Access Compliance Report

Public Rights-of-Way

Intersection ID: 9858	Main Street: MERCURY_ST	Cross Street: N_DAVIDSON_ST	Location: NE
ADA ID: AD8E5587231C	Ramp Type: PerpDiag	Initial Pass/Fail: Pass	Overall Compliance: No
Severity Score: 0			
Codes/Mitigation Info/Possible Solution		Field Measurements/Component Compliance

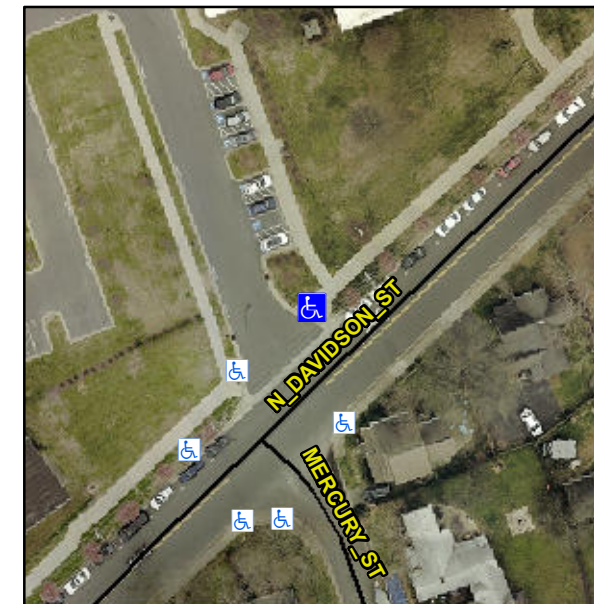
R304.5.3, R305.2

Remove & Replace Curb Ramp With Two New Directional Ramps or Equivalent.
